THE MARYLAND-NATIONAL CAPITAL PARK AND PLANNING COMMISSION

MEMORANDUM

DATE: December 3, 2003
TO: Montgomery County Planning Board
VIA: Joseph R. Davis, Chief
FROM: Michael Ma, Supervisor *ma*
Development Review Division
(301) 495-4523

PROJECT NAME: Bethesda View
CASE #: 9-04001
REVIEW TYPE: Project Plan

III. Compatibility with Adjacent Apartments

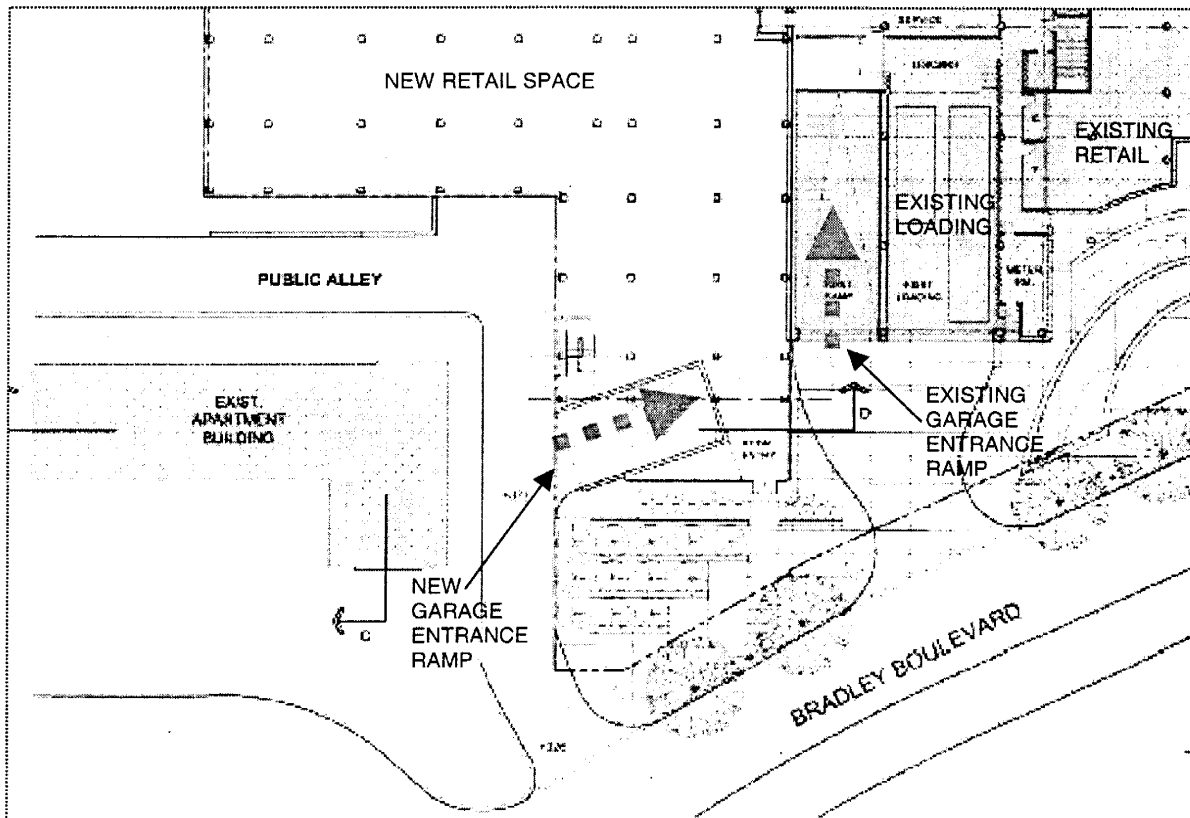
There are existing garden apartments located across a public alley from the northwestern portion of the proposed development. The development proposes a four-level underground parking garage. The first two levels will be provided for retail customers using the existing entrance ramp off Bradley Boulevard. The lower two levels of parking will be allocated to the residential portion of the development exclusively using a new entrance ramp off the public alley, approximately 75 feet off Bradley Boulevard, near the northwestern corner of the site.

- Apartment Owner Concern:
- a. The proposed new garage entrance off the alley is within 25 feet of several of the bedroom windows of the adjacent apartment building. The garage entrance should be redesigned to use the existing entrance directly off Bradley Boulevard to minimize the impact of vehicular pollutions and noise, electric gate noise, and alley traffic congestion on adjacent apartments and to avoid pedestrians safety problems.
 - b. The impact of the construction activities of the proposed development on the apartments.

The site has a frontage on Wisconsin Avenue, Bradley Boulevard, and the public alley. For a four-level, 389-space underground parking garage, it is desirable to have two separate entrance/exit points for circulation and safety reasons. The site currently has a vehicular entrance off Bradley Boulevard to the garage under the existing retail building. Having a new driveway entrance on Wisconsin Avenue is not feasible due to the traffic volume on Wisconsin Avenue and the fact that the site has other street frontages.

While the applicant's proposal includes a new residential garage entrance on the public alley which will increase residential vehicular trips, the applicant has eliminated all commercial loading and dumpster activity in the alley by the residential apartments. In addition, the applicant has setback into the building the electric parking gate so as to further minimize noises. At the time of site plan review, staff will work with the adjacent property owner and the applicant to review the design of the garage entrance and the surrounding areas in details to identify possible landscaping or other screening devices to address the impact of the new garage entrance.

Parking

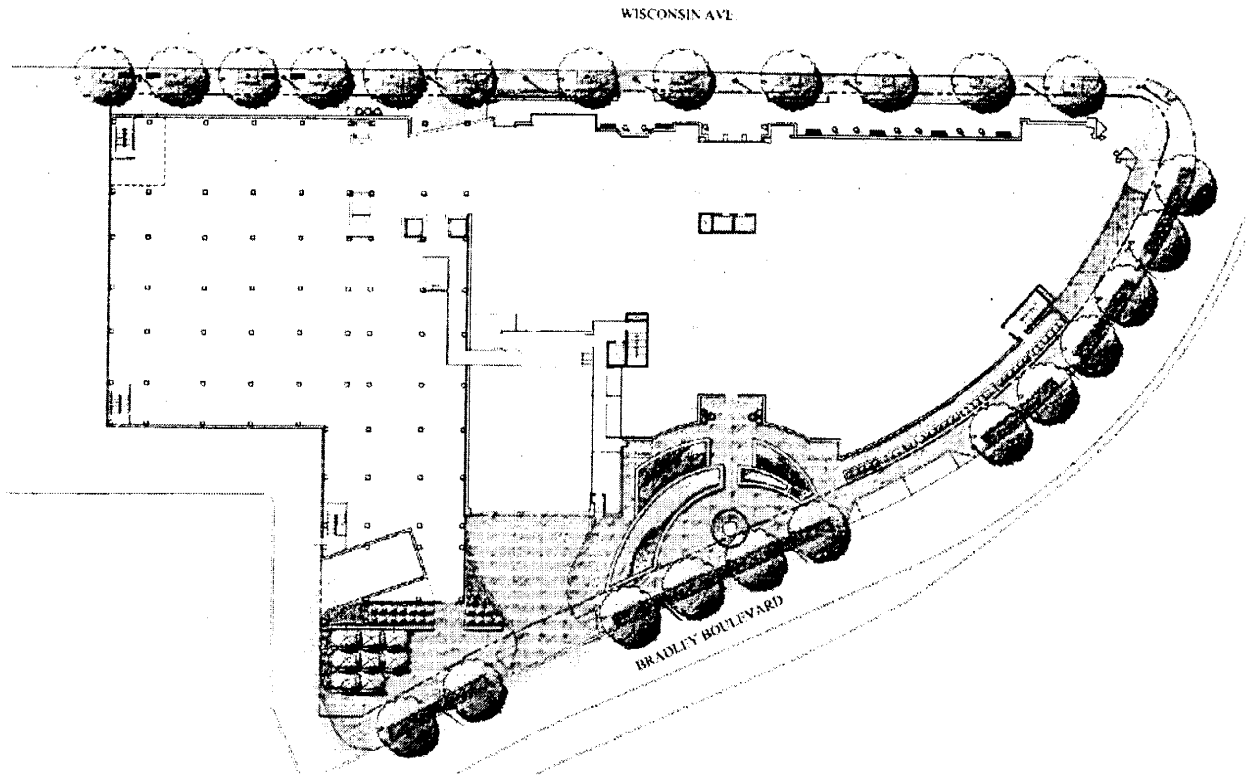
The new building will include a four-level, underground parking garage for use by residents, retail patrons and the general public. The new garage will contain a total of 263 parking spaces, with 146 spaces reserved for the residents and 117 spaces for the retail. With the existing 126 parking spaces located within the garage under the existing retail building, there will be 389 parking spaces serving the entire development. The new and existing parking will be connected internally.

The plan proposes two separate entrances for the residential and commercial uses of this development. The entrance ramp off of Bradley Boulevard to the existing retail building's underground parking will be used for the commercial uses of the entire development. The residents of the condominium units will have a parking entrance off of the public alley to their exclusive parking spaces in the two lower levels of the garage.
